4th April 2018

## **BGA RESPONSE TO THE LONDON OXFORD AIRPORT ACP CONSULTATION**

Figure 1 – Position of VFR choke points

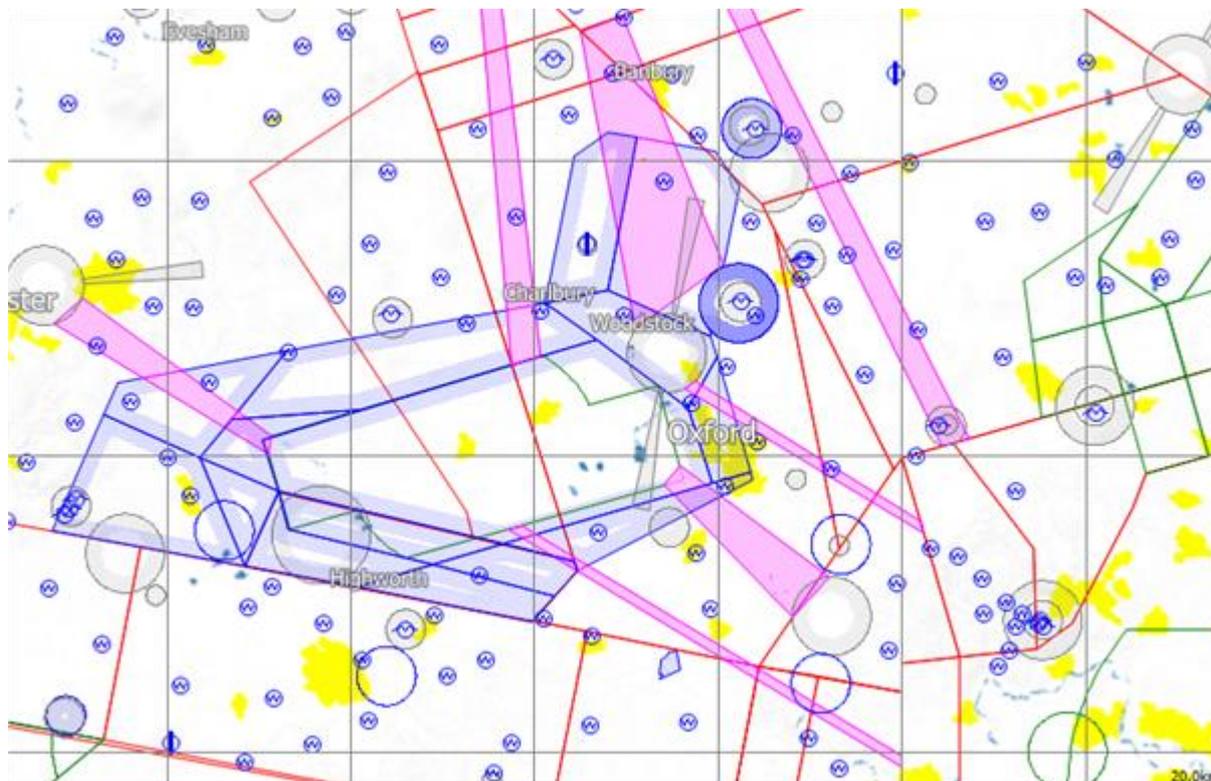
GA airspace is sufficiently well understood and predictable in its nature, such that the level of activity at any time can be calculated. More specifically, modelling can quantify the expected level of use and identify activity hotspots'. We have analysed present and proposed airspace widths and heights at known and projected choke points and have estimated the change in collision risk based upon guidance contained in AAIB Report 5/2010 if the majority of GA traffic elects (as is likely) to route around the proposed controlled airspace.

This analysis suggests that the risk of mid-air collision is roughly doubled at the south-eastern edge of the proposed airspace in the Brize Norton-Benson gap (East), and roughly trebled over the proposed Oxford CTR1 (North) and in the area around Kemble (West). Wholesale adoption by VFR traffic of extant GASCo recommendations regarding proximity from controlled airspace could see these risk levels elevated by an order of magnitude. Overall, we believe that the sponsor's decision not to conduct a meaningful analysis of either the LOA ATC capacity or the collision risk at GA choke points has wilfully misled the reader in respect of the level of risk that would be transferred to other airspace users, particularly GA.

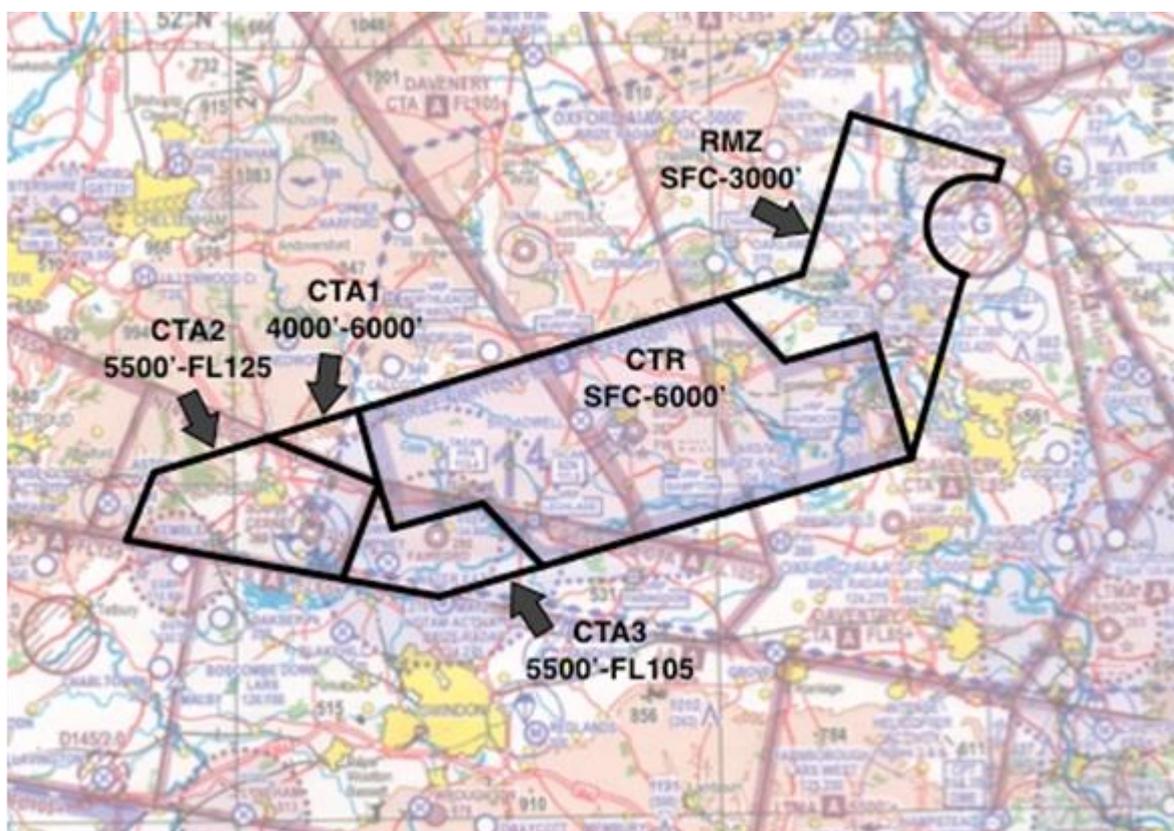
1. Introduces an RMZ as shown below with hours of operation as those of LOA.
2. Makes significantly greater progress in developing the substantial number of Letters of Agreement required and ensures that these reflect pragmatic solutions to interoperability and avoid practices which restrict extant operations.

7. Considers together with RAF Brize Norton the alternative airspace design we propose at Annex A which, in conjunction with the adoption of the above recommendations, will help achieve the sponsor's objectives, but without the addition of Class D airspace at LOA. Procedure design work has been undertaken to ensure it is possible to achieve this reduction and we would welcome more detailed discussion with the sponsor to ensure it is compatible with their operational requirements.

- Implementing a RMZ as indicated above;
- Implementing enhanced coordination with RAF Brize Norton ATC in a single collocated unit;
- Developing the LOA Runway 19 MAP as suggested to avoid flying over the built-up area of Oxford CTR;
- Mitigating overall risk to ALARP for all airspace users.
